COMMENT PROVISION RESPONSES. ORIGINAL COMMENTS PROVIDED BY PLANNING BOARD OF THE VILLAGE OF UPPER NYACK WEDNESDAY, NOVEMBER 18, 2009 COMMENT RESPONSES FOLLOW

202 HILLTOP DRIVE UPPER NYACK, NY 10960

FINAL SITE PLAN

C-100.00

SITE PLAN

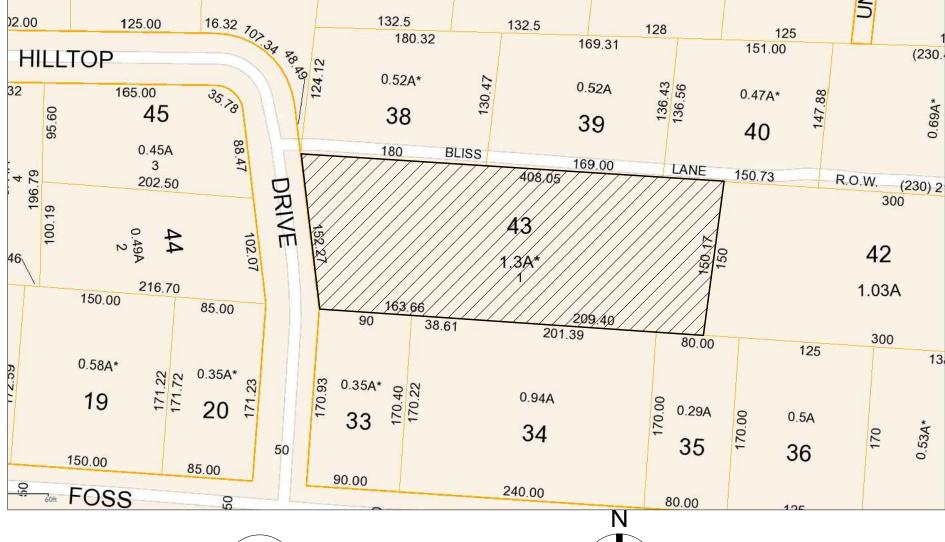
SHOW DIMENSIONS OF POOL HOUSE POOL HOUSE DIMENSIONS HAVE BEEN ADDED

2. RELOCATE AC UNIT/COMPRESSOR ON SOUTH SIDE OF THE HOUSE TO BACK OF HOUSE EXISTING SLIDING DOORS PRESENT AT SOUTH SIDE OF HOUSE, AC COMPRESSOR INSTEAD LOCATED AS SHOWN AND SCREENED WITH RUBBLE EMBANKMENT AND PLANTING SCREENING

3. ADD NOTE STATING WALLS TO BE NATURAL STONE (NOT CONC.)

4. ADD NOTE STATING EXTENSION OF CURBING INTO SEEDED AREA ON BLISS LANE

5. ADD NOTE STATING NO LIGHTING TO BE LOCATED ON SOUTH SIDE OF PROPERTY

- THE AIR CONDITIONER COMPRESSOR UNITS HAVE BEEN RELOCATED SO AS NOT TO OBSTRUCT THE EXTERIOR DOORS IN THE LOCATION ORIGINALLY SPECIFIED. THE UNITS ARE SUNKEN INTO A "WELL" SURROUNDED BY STONE WALL AND PLANTINGS ALONG THE NEIGHBORING PROPERTY LINE.
- AN 18" CURB HAS BEEN INSTALLED EXTENDING NORTH-SOUTH ACROSS THE BACK YARD. THE CURB IS COMPRISED OF LOOSE-LAID STONE. A DETAIL HAS BEEN ADDED TO THE DRAWING OF THE **INSTALLED CONDITION**
- STONE PAVER STEPS AND STEPPING STONES HAVE BEEN INSTALLED TO PROVIDE A PATH FROM THE PRIMARY DWELLING TO THE POOL AREA. THESE STONES VARY IN SIZE, BUT RANGE FROM AN ESTIMATED 2'X2' TO 3'X4'. THESE SURFACES ARE DISCONNECTED FROM ANY LARGE IMPERVIOUS AREA AND ANY IMPACT ON DRAINAGE IS NEGLIGIBLE

• A DRY-LAID STONE PATIO HAS BEEN INSTALLED TO THE EAST OF THE PORCH AREA AT THE REAR OF THE PRIMARY DWELLING. THE DRY-LAID STONES ARE AN AVERAGE OF APPROXIMATELY 8" X 12" AND ARE SEPARATED BY AROUND 1" TO 2" WITH GRASS AND/OR SOIL BETWEEN. THE PATIO AREA IS CONFINED WITHIN STONE WALLS AS SHOWN ON THE ORIGINAL SITE DRAWING. THIS PATIO COMPRISES 1176 SQUARE FEET OF GROSS SURFACE AREA, WITH A SIGNIFICANT PORTION OF THE SURFACE COMPRISED OF GRASS OR EXPOSED SOIL

NOTE ADDED
